Arapuca position and fiber position for Module 0 !!

NP02-module 0 arrangement

Xar output direction
Module 0 = FD2 solution

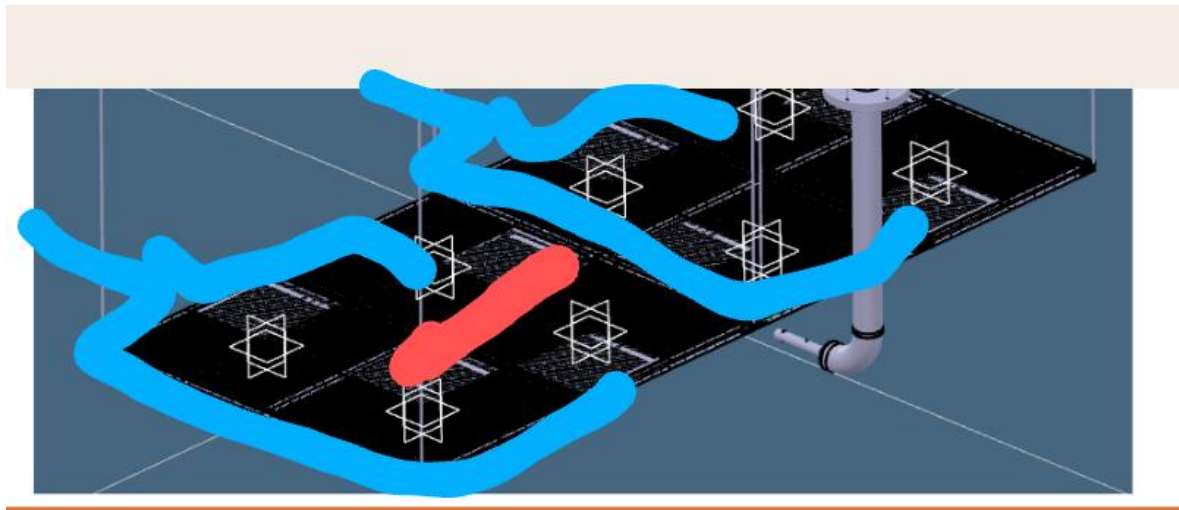
One global output in FD2: is it still true ? Up or down ?

Ryan proposal n°1

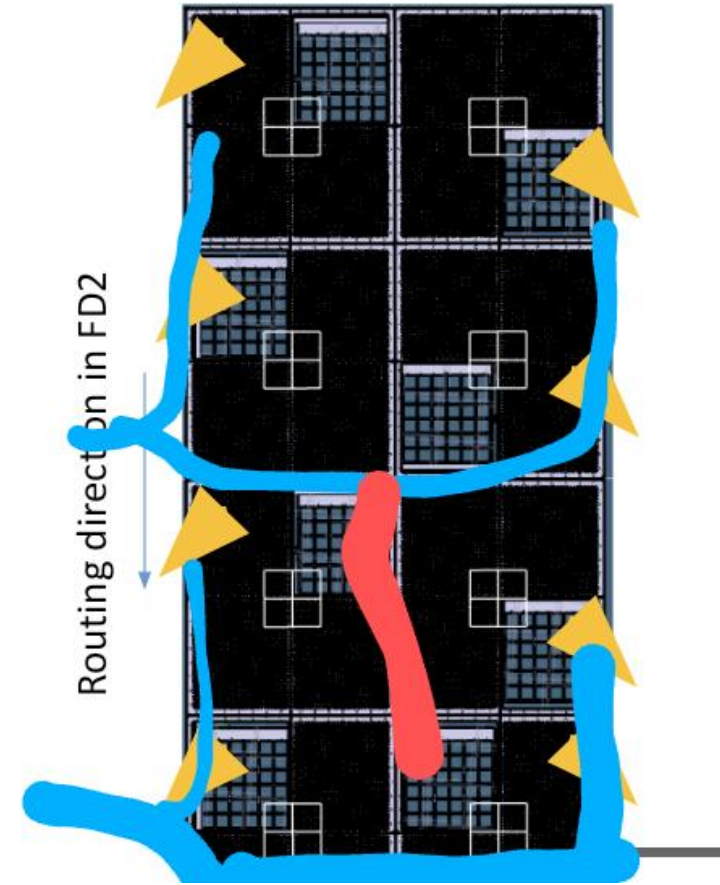
Problem: the 2 cathodes must be independent in Module-0

=>The fibers must find a new routing

Problem is the mirror symmetry

Path to get out from module

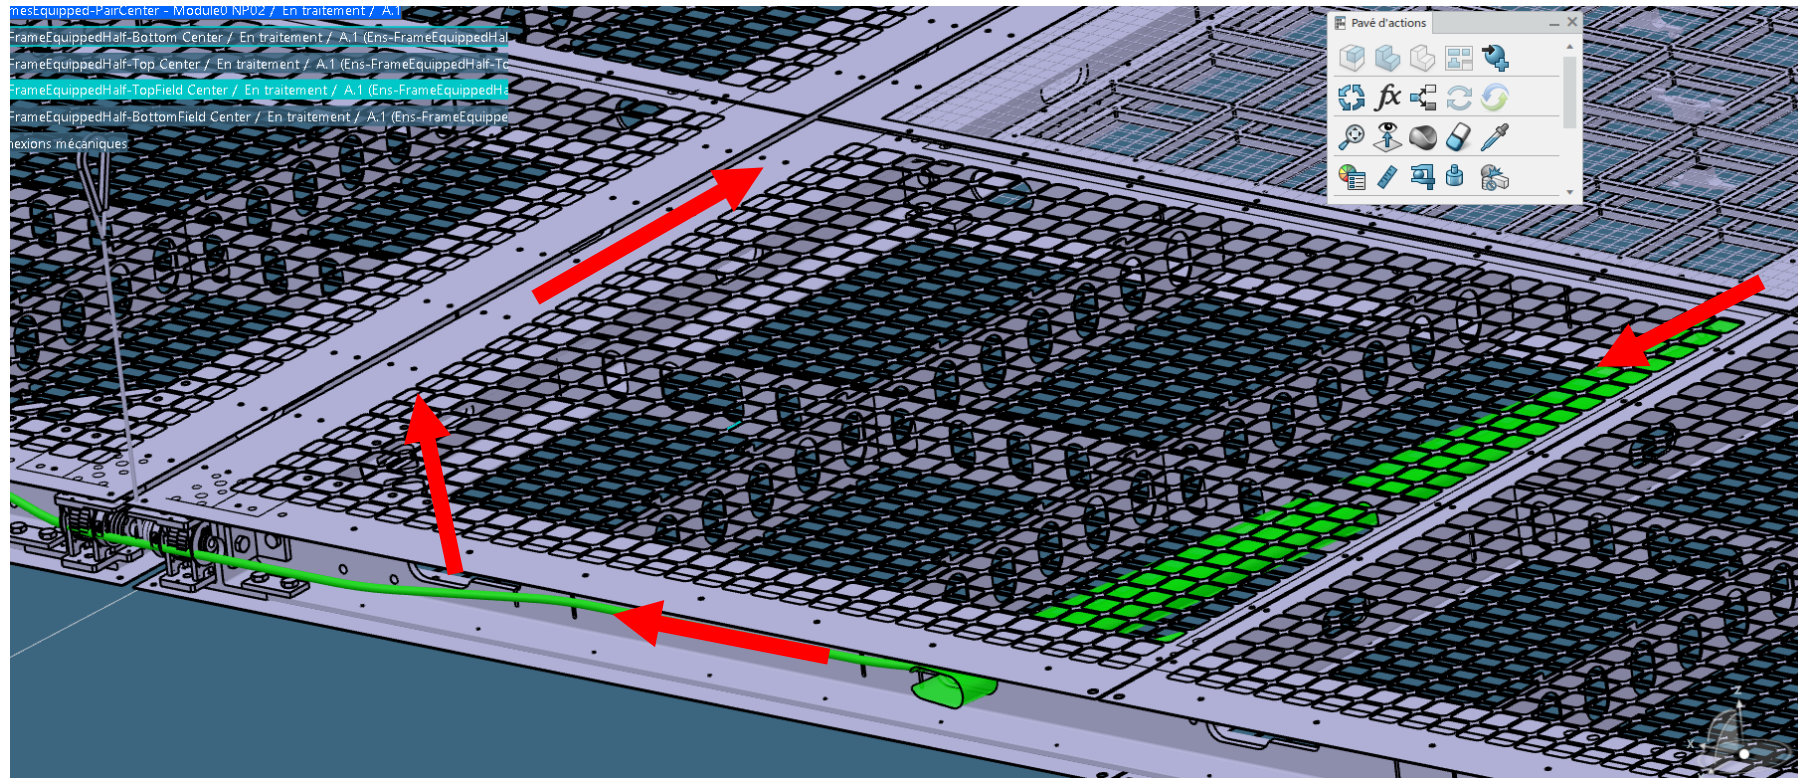
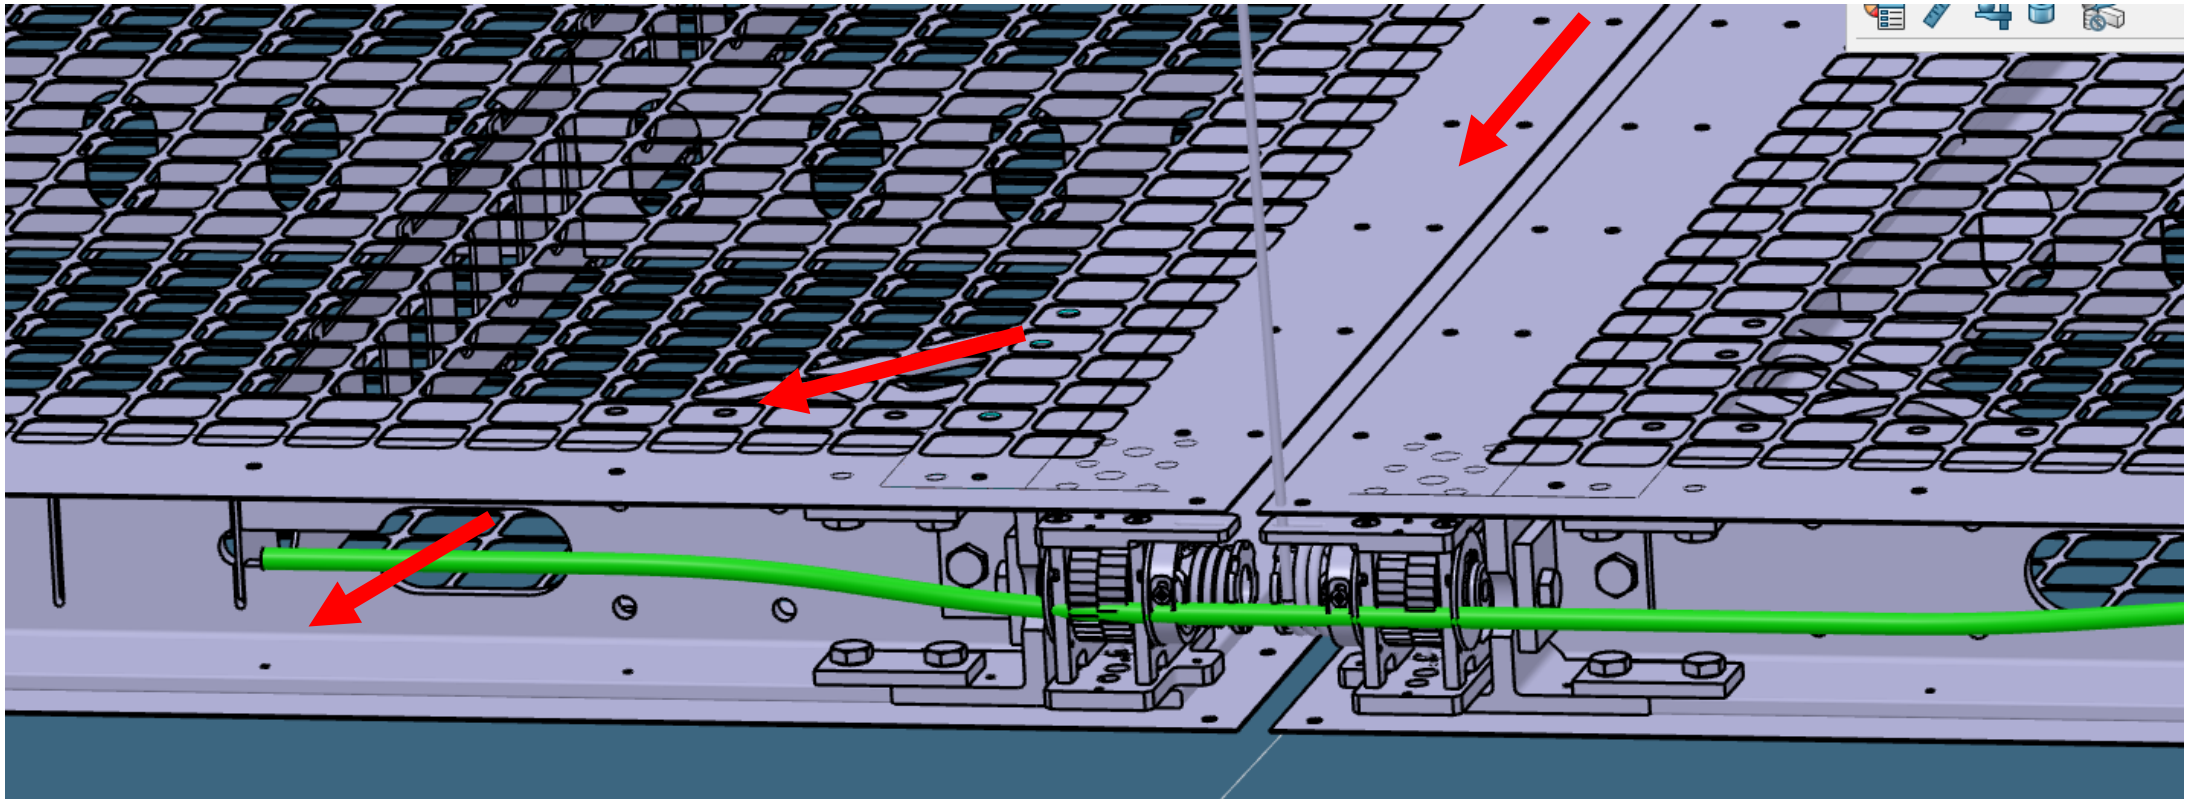
Respect of the module output directions and single cathode behavior
Need 2 outputs !! Up or down ?

Path to get out of the cathode towards field cage

After the cathode, what is the status ? through field cage, up or down ?

Mesh finger

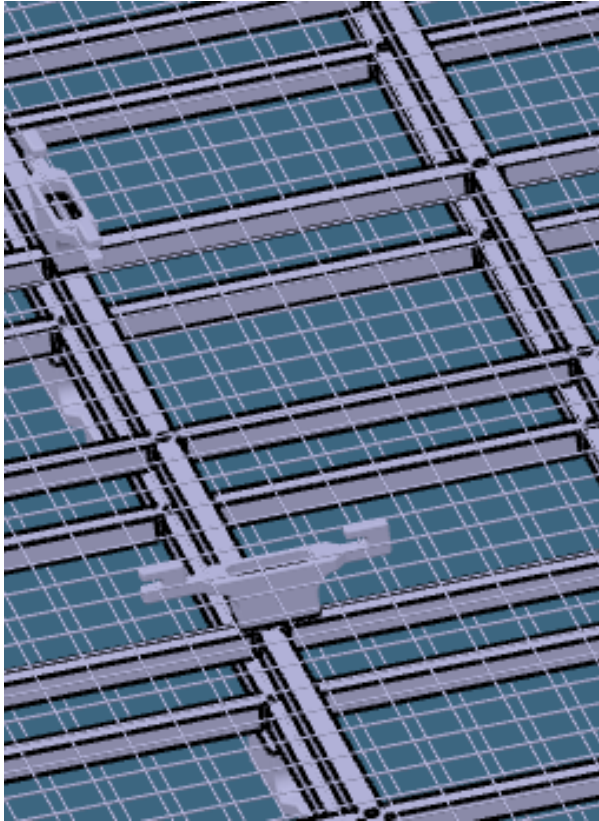
Status ? (from Paul Debbins ?)

Critical distance between mesh and boards

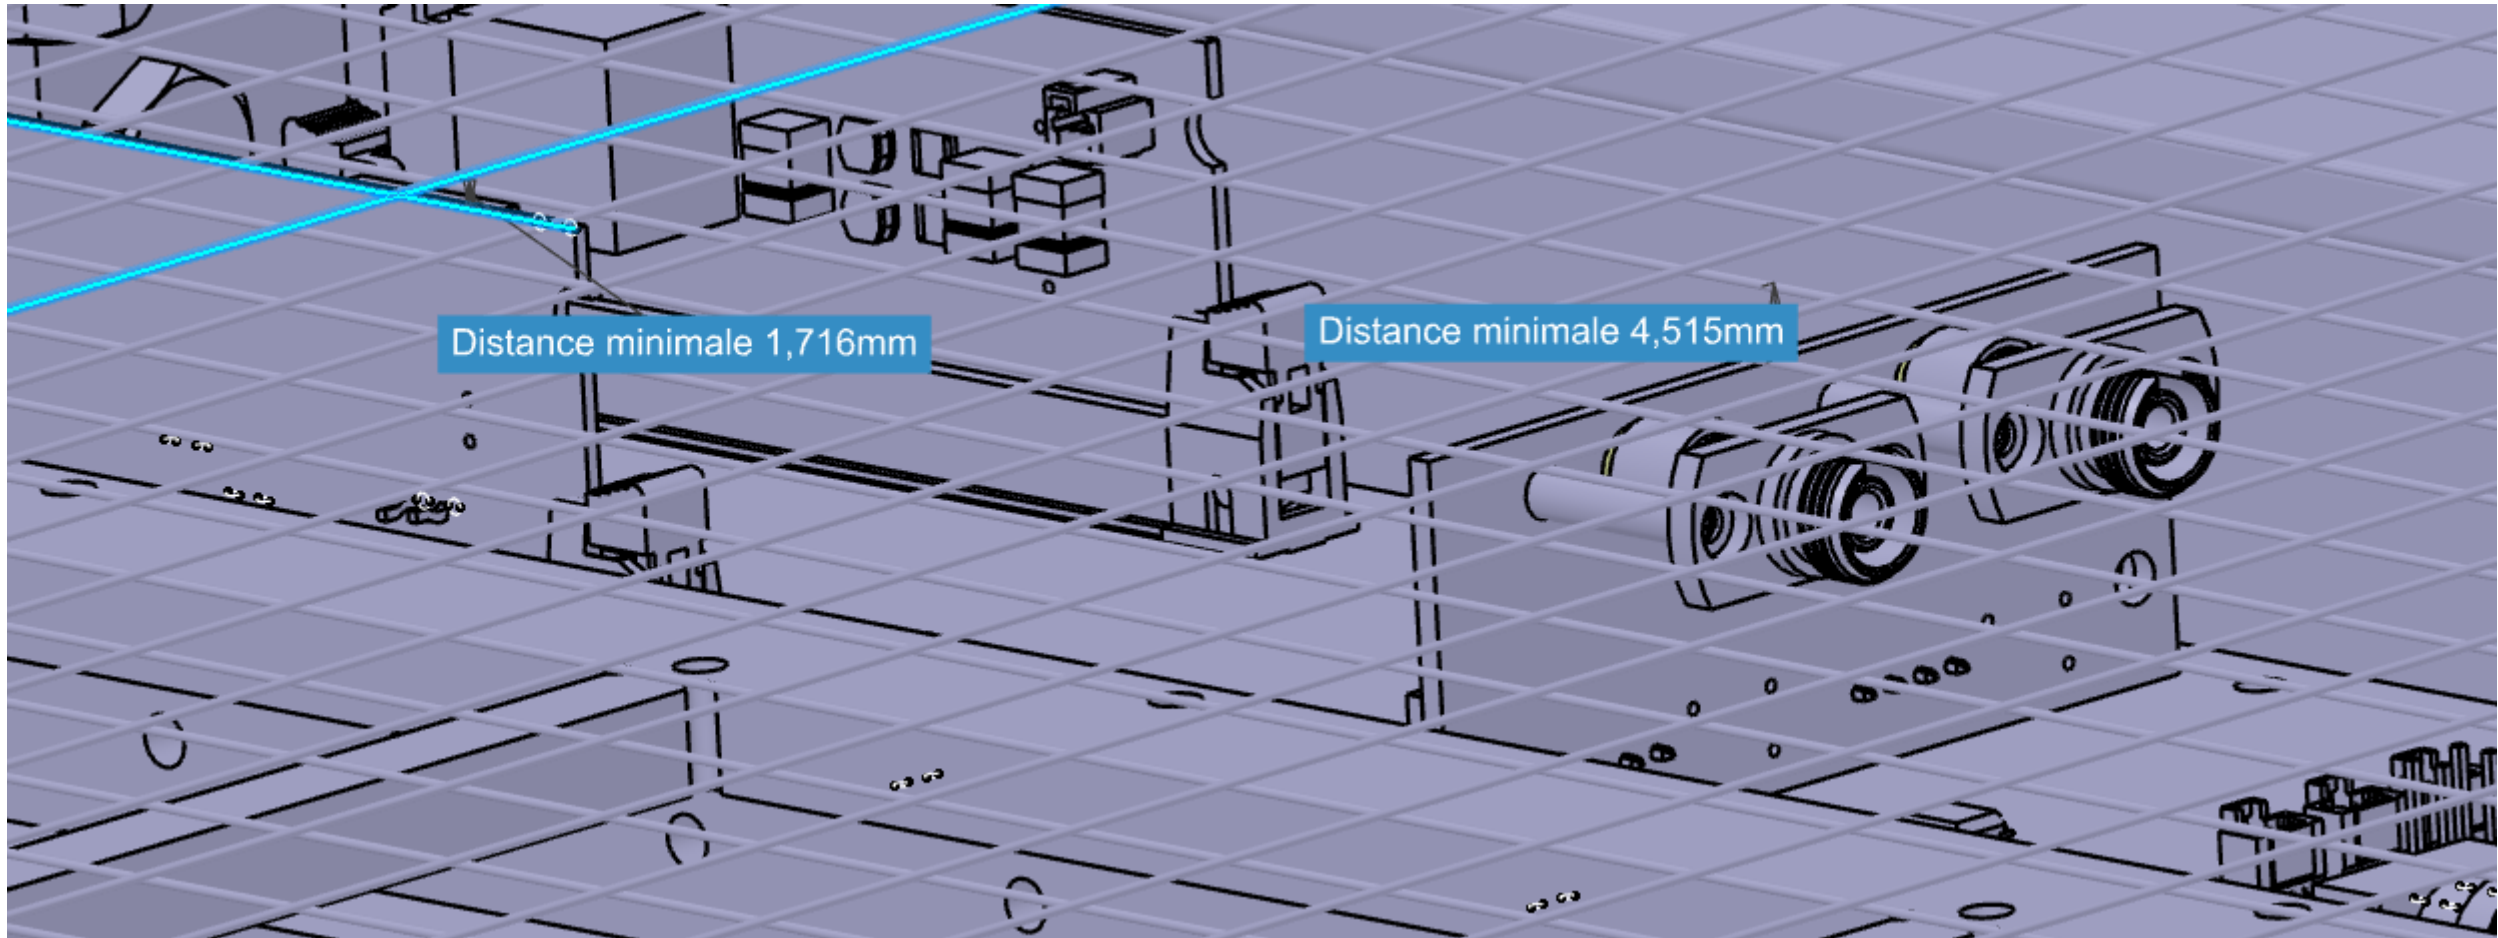
Did you change something about that ?
